DRAFT FOUNDATION INVESTIGATION REPORT

HWY 401, STA. 16+180 CULVERT EXTENSION

**HWY 401, STA. 14+569 RETAINING WALL AT CULVERT
DISTRICT 43, BANCROFT**

Re: Response to Evaluation of Draft Foundation Investigation & Design Report
Hwy 401, Bancroft: WP 271-96-00 and WP 273-96-00

REC				
	DATE	BY	DESCRIPTION	
GEOCONS Na				
HWY No 401			DIST 4.3	
SUBM'D	PC	CHECKED	DATE 199-10-12	SITE
DRAWN	GBB	CHECKED	APPROVED	DWG 11258-2

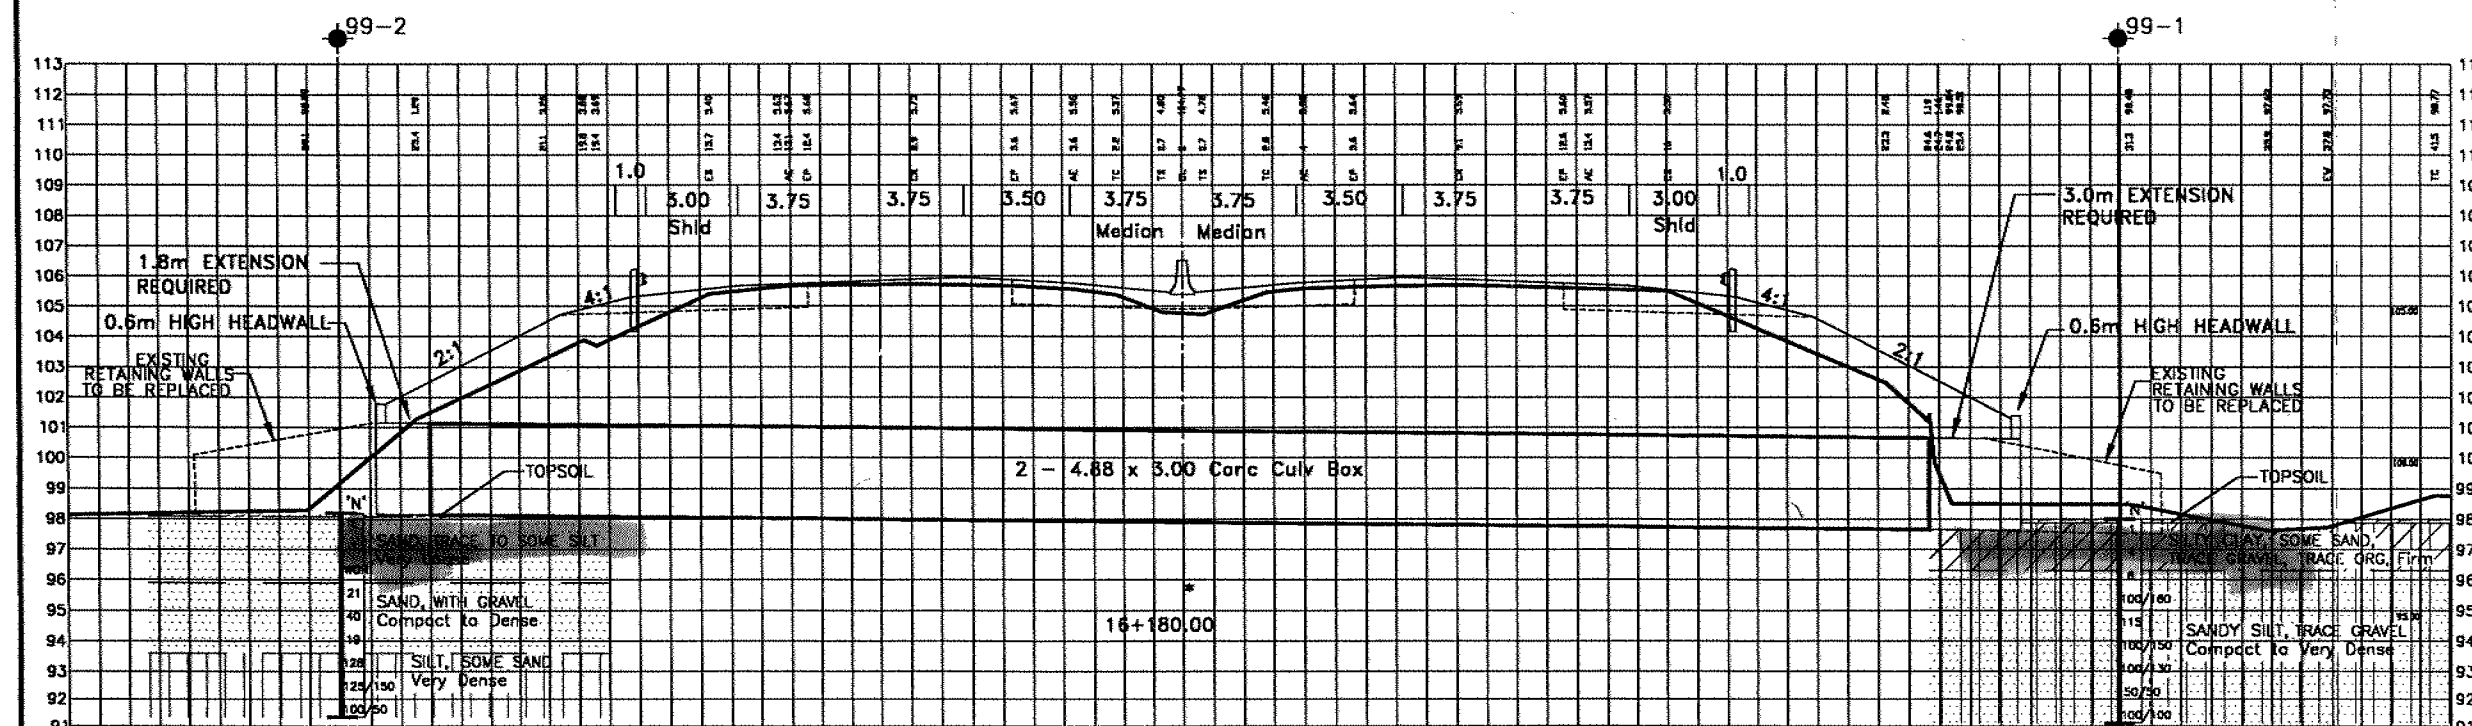
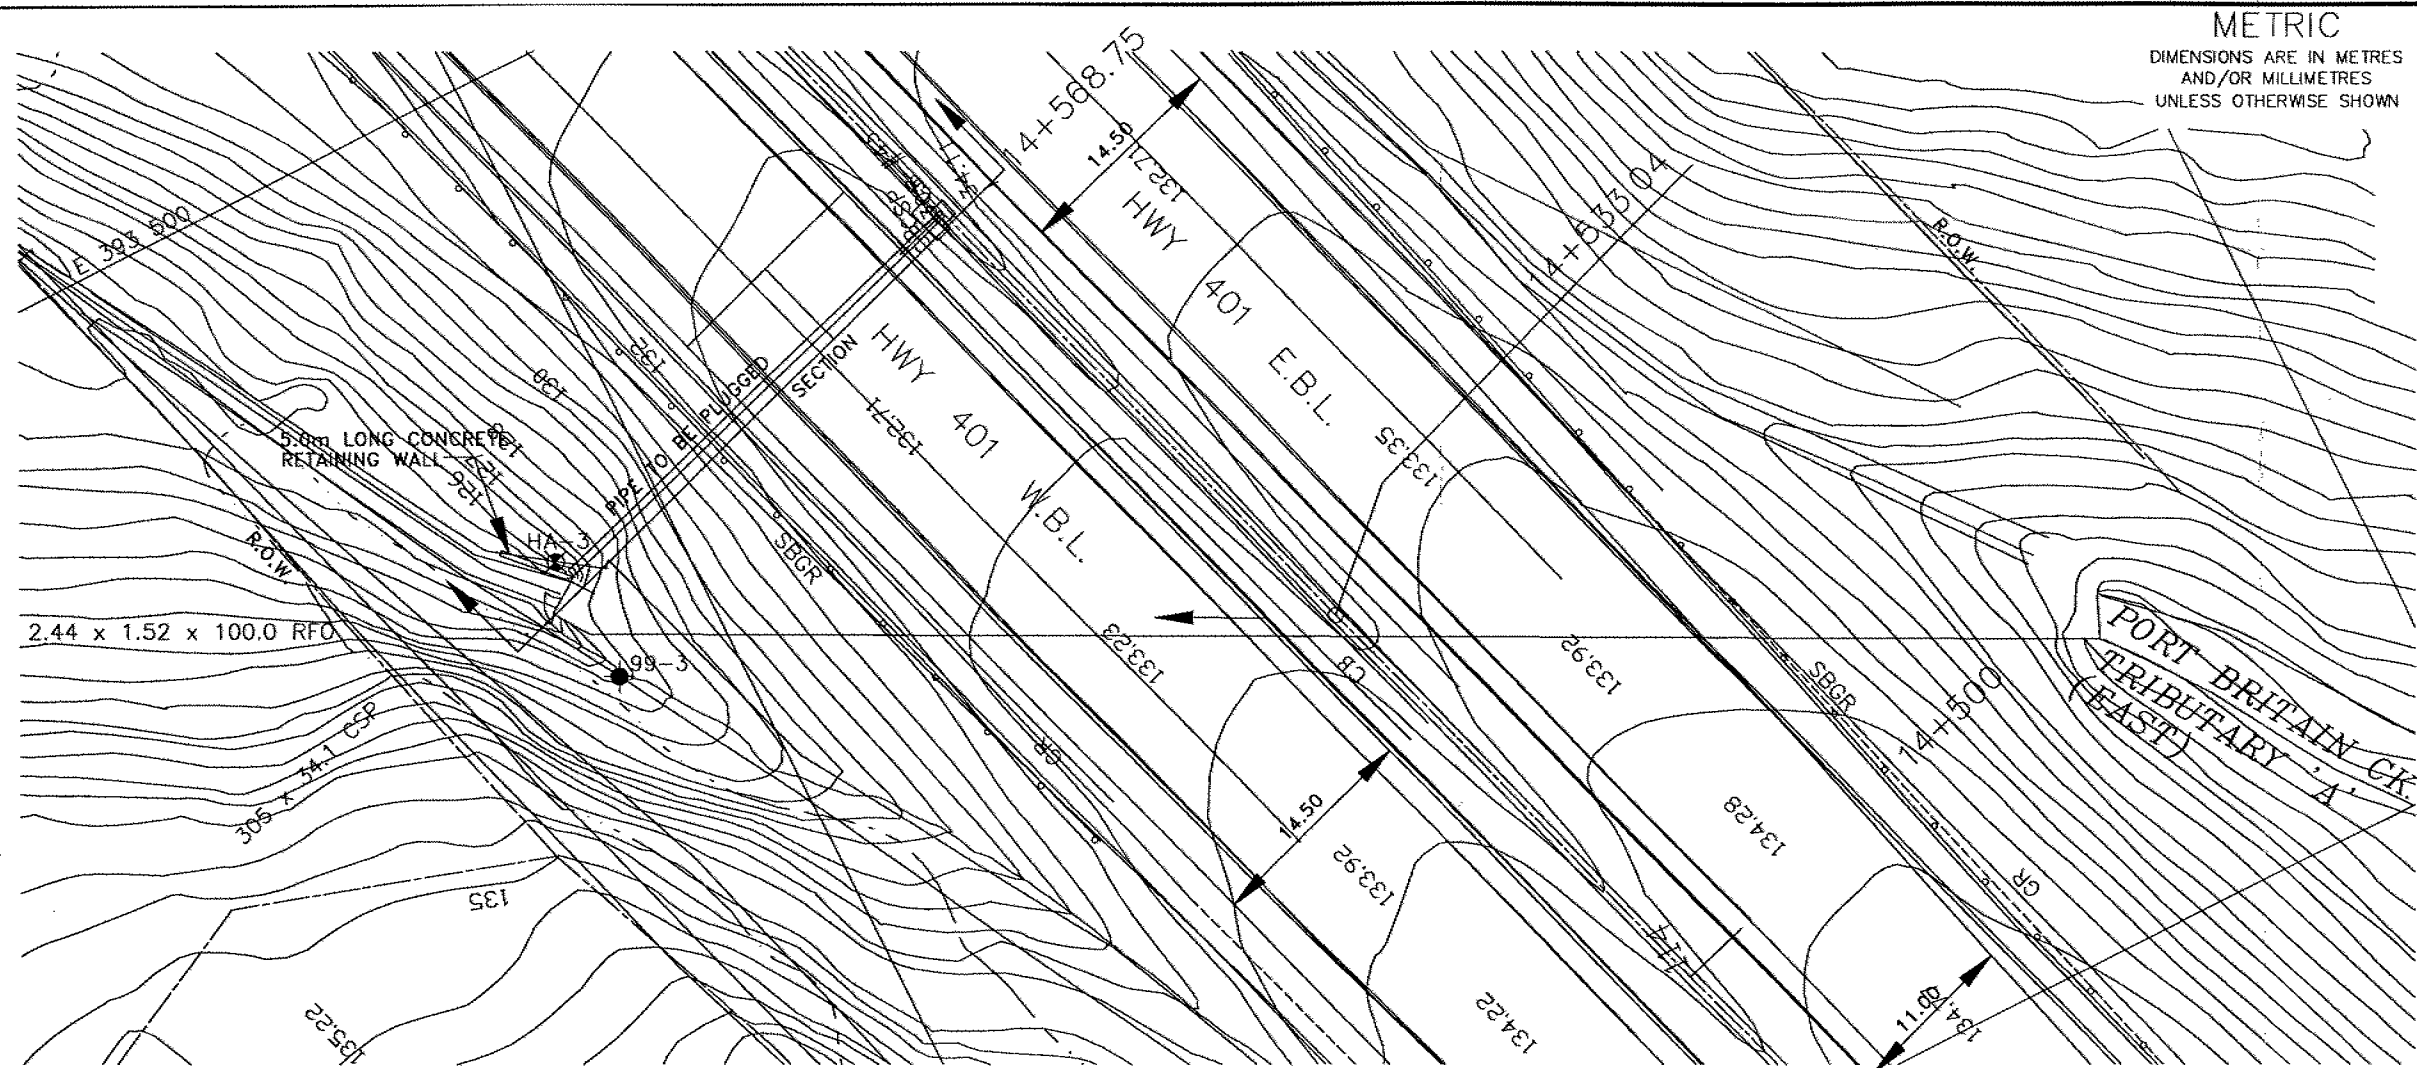
A borehole location plan and a cross section of the soils encountered within the boreholes at Sta. 16+180 is shown on Drawing No. 11258-2.

why in case
p223

The overburden soils encountered at the south end of the culvert (Borehole 99-1) consisted of silty clay fill overlying a deposit of glacial till. The silty clay fill extended to a depth of 1.7 m and contained some sand and trace amounts of gravel and organic matter. The moisture contents of the two samples tested were 21 % and 23 %. The silty clay fill generally had a firm consistency. The glacial till deposit consisted of sandy silt with a trace amount of gravel and was in a very dense state. The moisture content of three samples tested ranged from 7 % to 8 %. The borehole was terminated within the very dense glacial till deposit.

based on what

The overburden soils encountered at the north end of the culvert (Borehole 99-2) consisted of sand overlying sand with gravel, overlying a silt deposit. The sand deposit extends to a depth of 2.3 m and contains some silt and trace clay. SPT N-values within the sand were no greater than 1, indicating a very loose deposit. The very loose sand is underlain by a deposit of coarse sand with gravel. SPT N-values within this deposit varied from 19 to 40, indicating a compact to dense material. The moisture contents of two samples tested were 10 %. A grain size analysis carried out on a sample of this material indicated that it contained 33 % gravel, 55 % sand and 12 % fines. The coarse sand with gravel extended to a depth of 4.6 m and was

based on what
